Towne Center at Shelter Ridge

March 15, 2018 for Inland Wetlands Commission Application #17-14
Bridgeport Avenue, Mill Street, Old Kings Highway, and Buddington Road

Report by the City of Shelton Natural Resources Manager, Teresa

Version reviewed: Plan set date stamped ‘received’ December 21, 2017 by Inland Wetlands; Stormwater Management Calculations dated December 22, 2017.

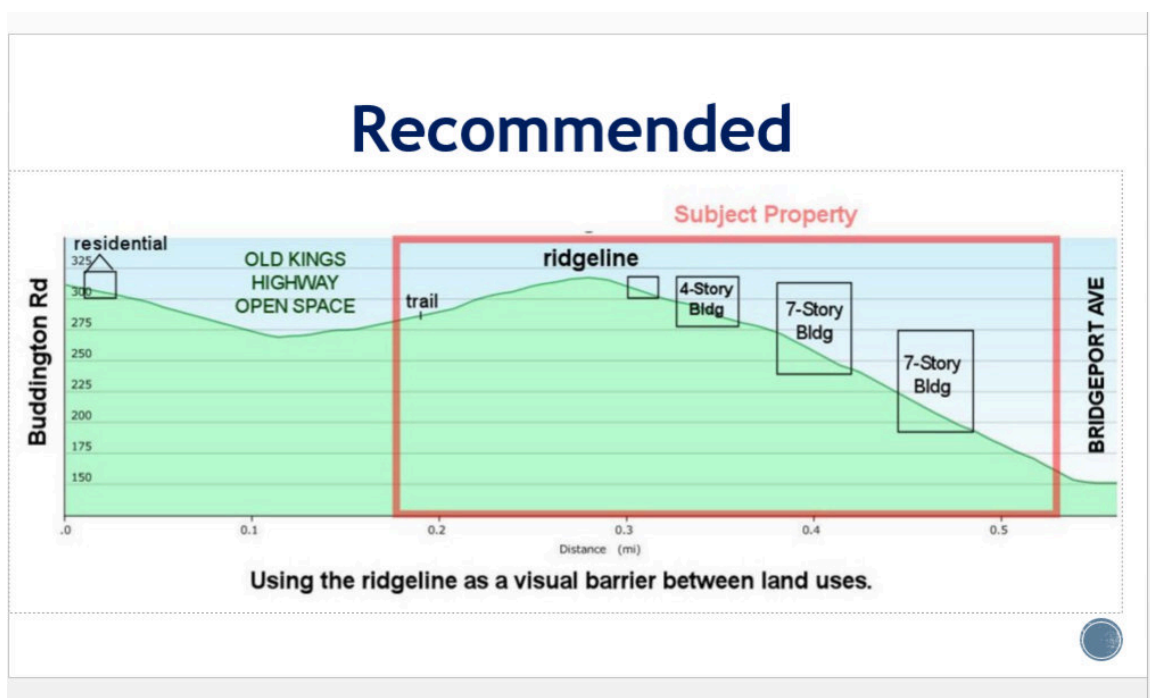
1. Paugussett “Blue Dot” Trail: The site plans depict a trail labeled the “Paugussett Blue Dot Trail.” This should be removed from the current site plans, since the route shown is not in any way realistic, as was made clear during the Planning and Zoning Commission public hearing. Extension of the Paugussett Trail to the Stratford border has been part of Shelton’s Plan of Conservation and Development and Open Space Plan since 1993. The trail was to specifically cross Buddington Road, pass through the Old Kings Highway Open Space, then follow the top of the hill parallel to Mill Street to arrive at Bridgeport Avenue.

This route, however, assumes that the ridgetop crossing the Shelter Ridge property is not developed, serving to shelter the open space areas from the Bridgeport Avenue corridor. The site plan under review does not meet these criteria, but instead shows an untenable hiking trail routed along the base of commercial buildings, parking areas, and apartment towers. The State of Connecticut has designated all CT Blue-Blazed Hiking Trails the “primary hiking trails” of Connecticut. These hiking trails do not pass through extensively developed areas, but require a natural corridor and at least the illusion of wilderness. New trail sections must consist of scenic routes. The Connecticut Forest and Park Association (CFPA) manages the 825-mile Blue-Blazed Trail system and

Proposed open space

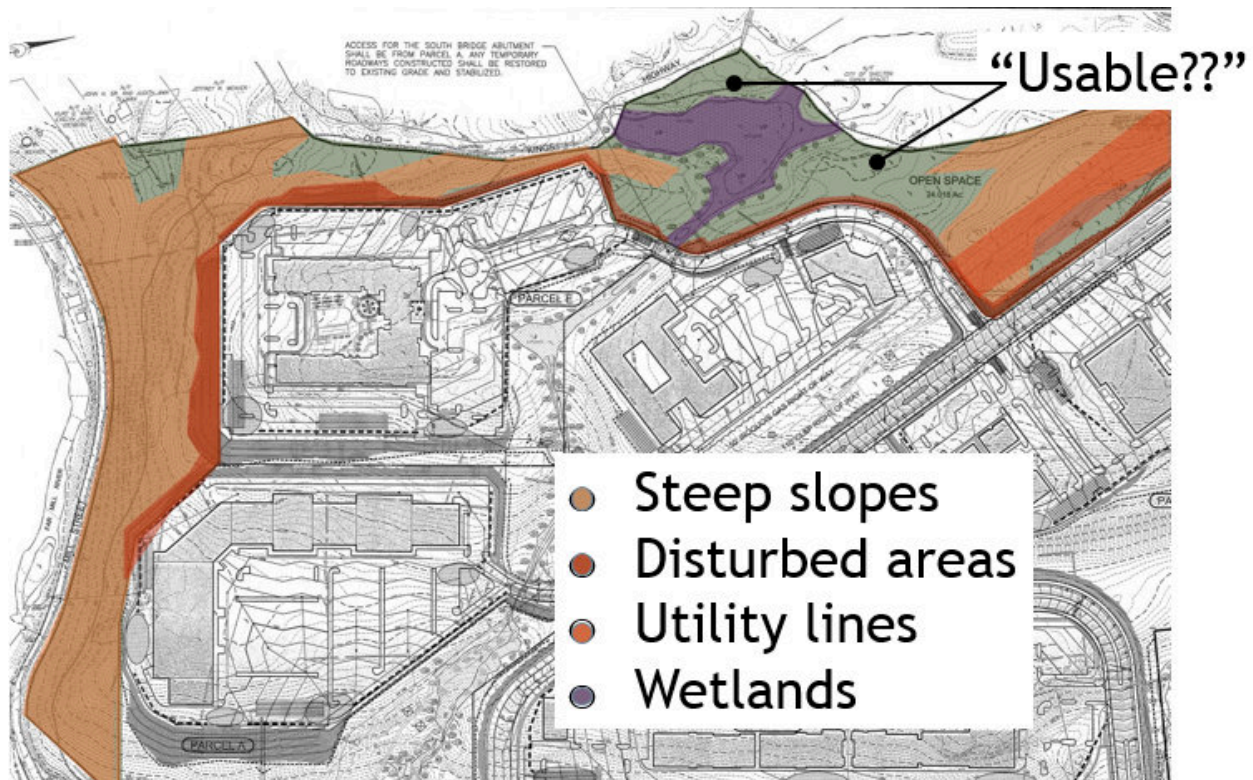
3. Proposed Open Space. Twenty-four acres are proposed as open space. The open space set-aside is “implied mitigation” for the proposed impacts to wetlands and watercourses. These proposed open spaces are not meaningful open space and may present a liability to the city.

- The steep slope above Mill Street, with commercial and high density residential development perched directly above and overlooking the steep slope. With the development overlooking the hillside, there is little recreational opportunity (there is no public desire for a hiking trail next to intensive development). The proximity to intensely developed areas suggested portions of this open space will be impacted by construction activities, future dying trees due to impacted root systems, and invasive plant species. Litter from the development is likely to blow down the steep hill where it will be highly visible from Mill Street (the City’s first designated Scenic Road) and where it will be left as a City problem to address. Shelton’s Anti-Litter Committee has noted problems with landscaping crews at commercial establishments using leaf blowers to blow litter off of parking and landscaped areas down into the nearest steep drop off. Note that the hillside

- West border of the site: This open space does provide a very minimal buffer to the Old Kings Highway historic colonial roadbed and vernal pool, but that buffer is insufficient considering the sensitivity of the site location within the Shelton Lakes Greenway. The proposed open space includes many areas that will be directly impacted by site grading, the 60-ft. wide gas pipeline, 110-ft wide CL&P corridor, emergency access road to Buddington Road, and new stormwater drainage features. The applicant would apparently deed these areas, which have little or no public recreational value, to the City to manage. While utility corridors may be appropriate to include when combined with other meaningful open space, graded and disturbed areas generally are not. These latter areas tend to develop chronic problems including encroachments, invasive species, litter, and dying trees that need to be addressed by city staff. Moreover, such areas tend not to be scenic or have any recreational value.
